ADDENDUM NO. 2

**New Premium 63 Site Loop Campground
St. Francois State Park
Bonne Terre, Missouri
PROJECT NO.: X2317-01**

August 29, 2025

CAD DWG FILE: X2317-DS-501
DRAWN BY: BAB
CHECKED BY: RKS
DESIGNED BY: RKS

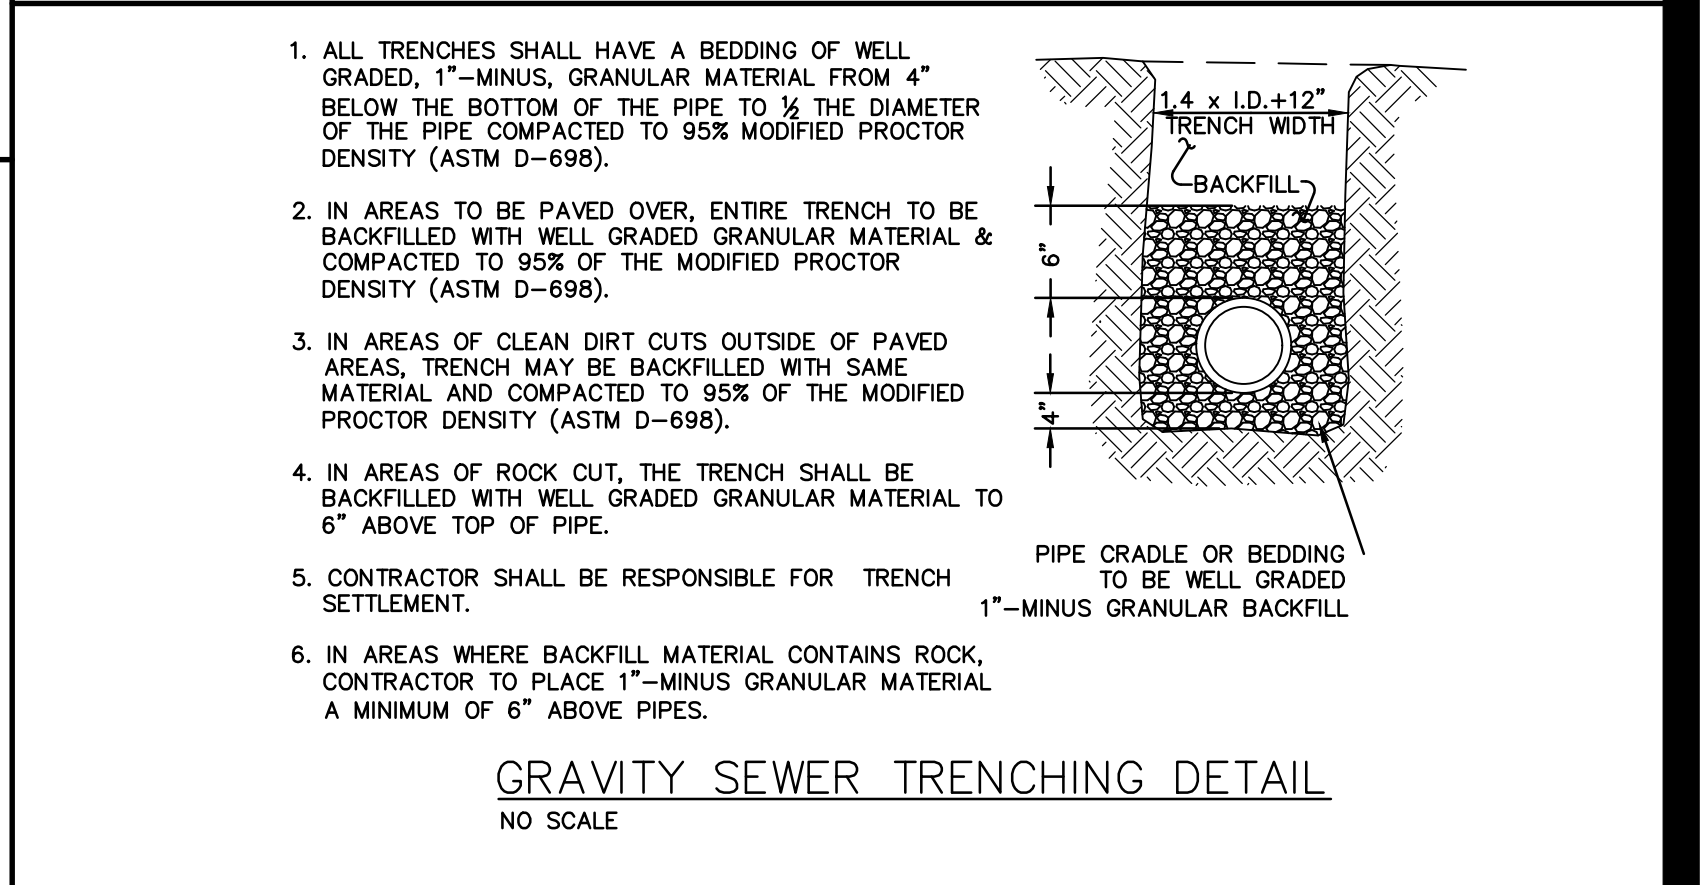
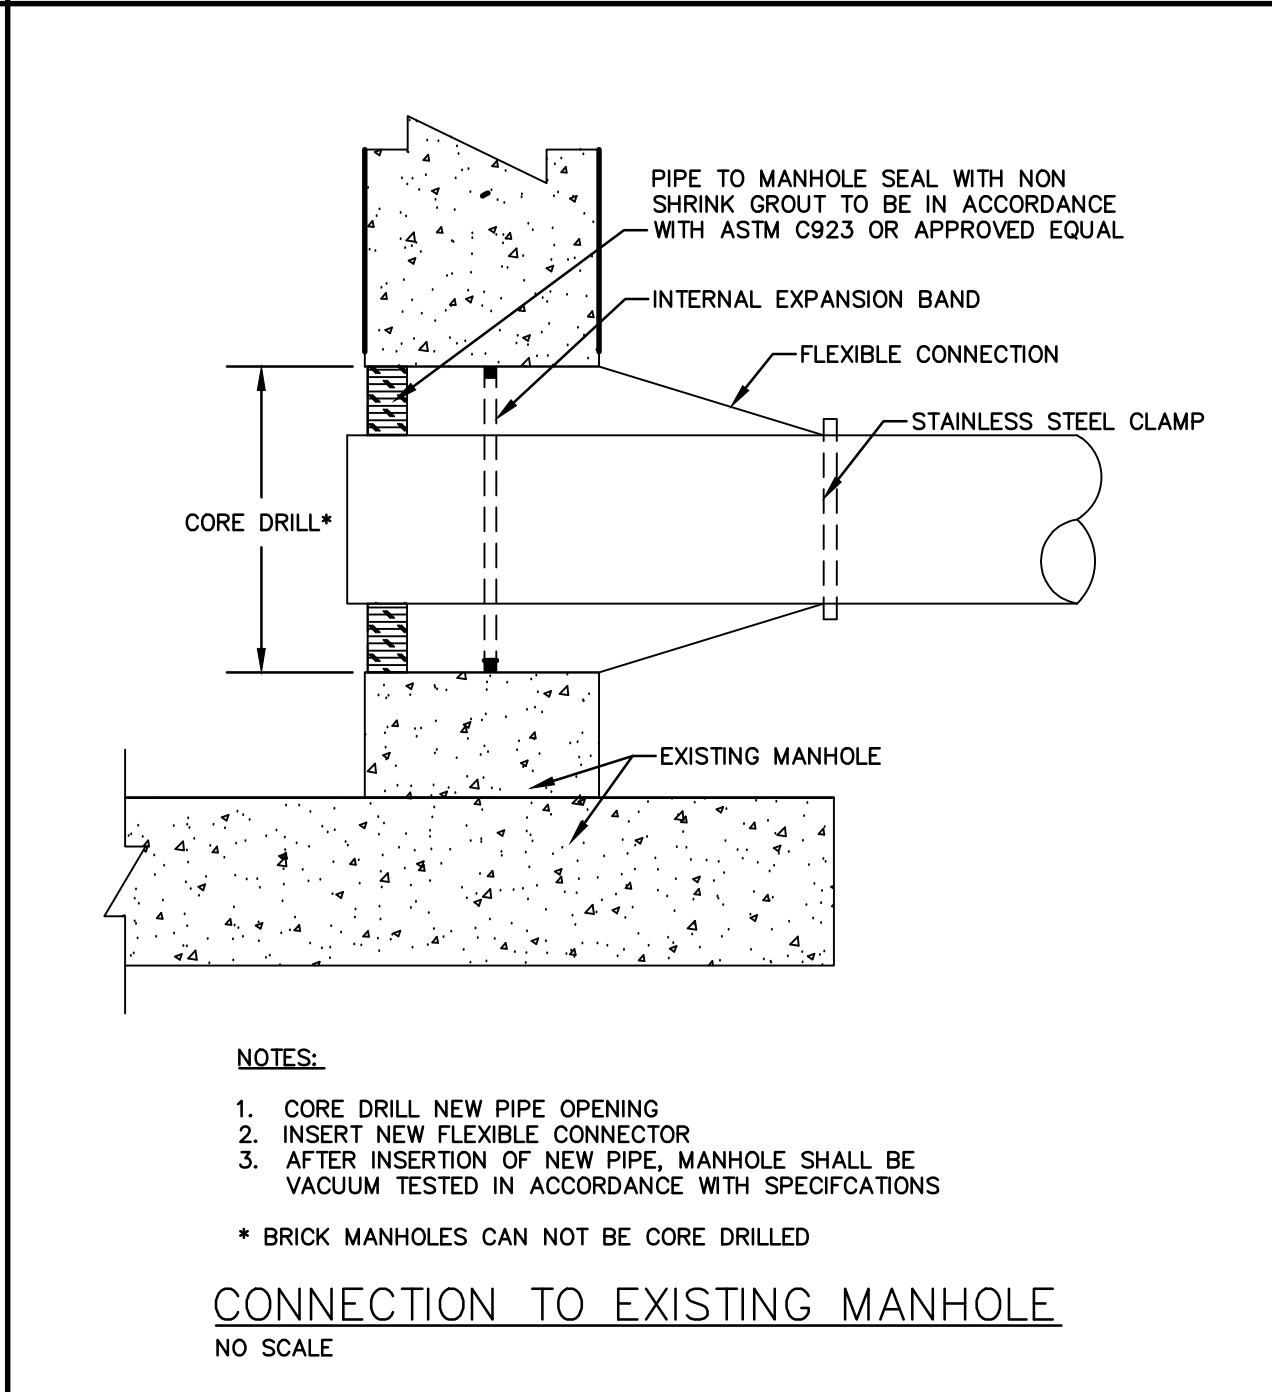
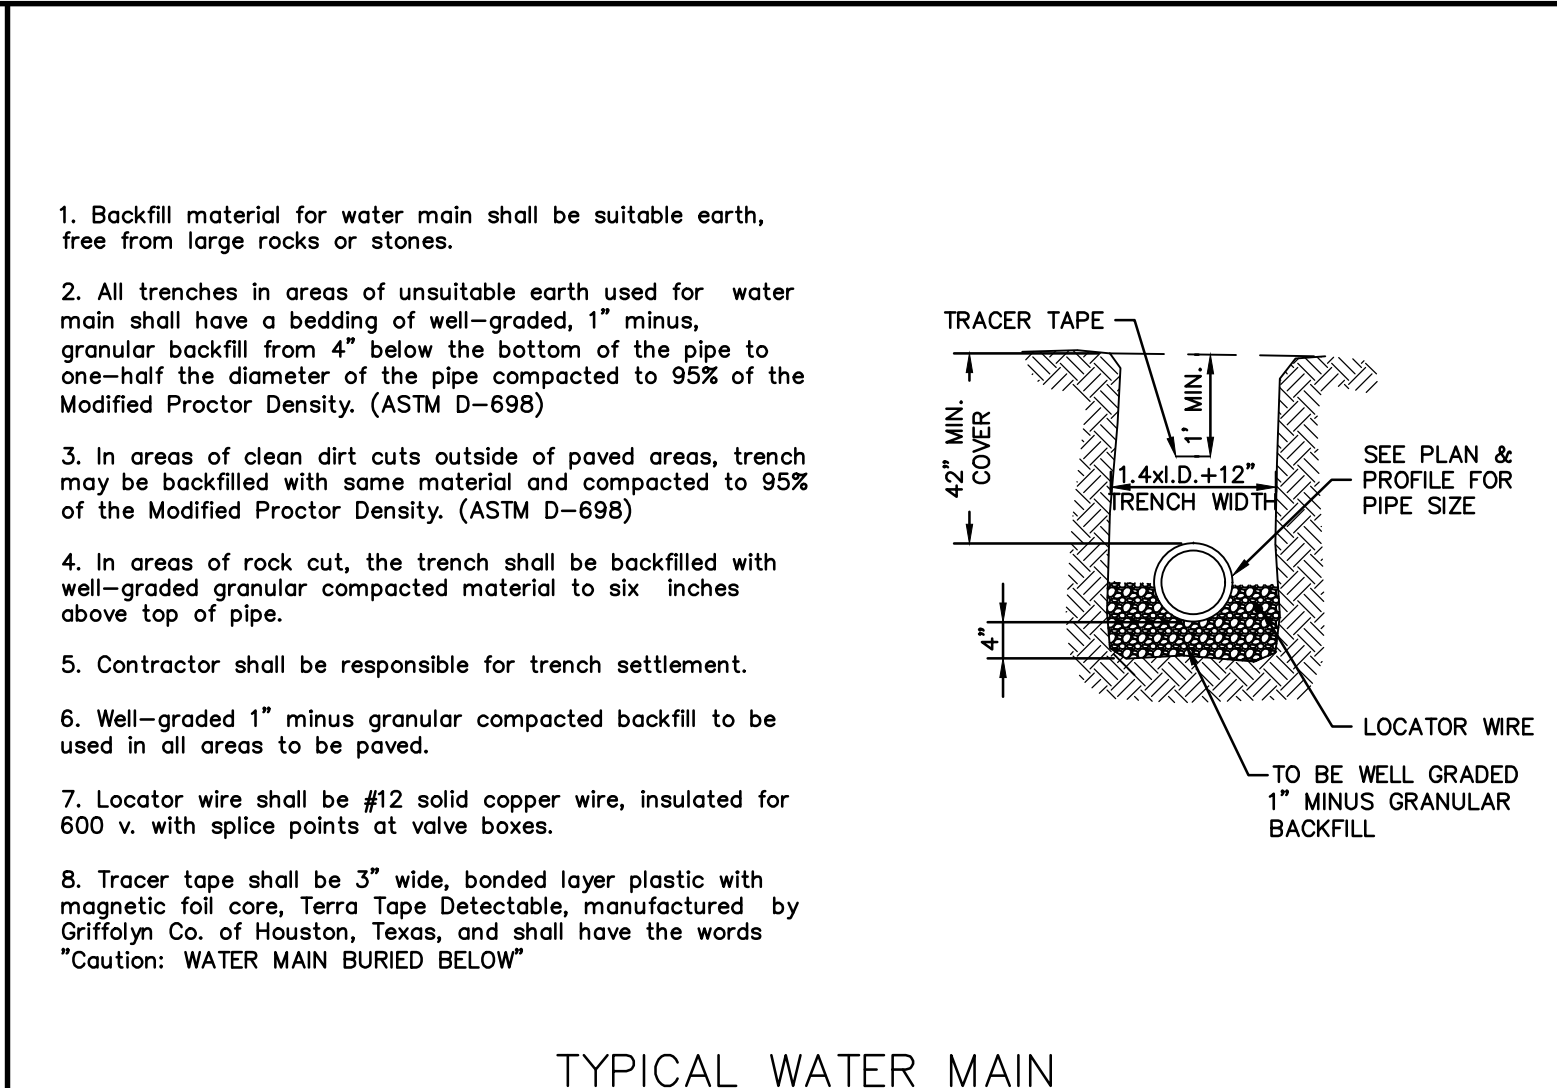
1. Three control joints have been added around the fire pits to avoid cracking.
2. Lantern hanger location moved to adjacent to the concrete pad as shown in the lantern detail.
3. Removed Alternate Concrete Paving Detail.
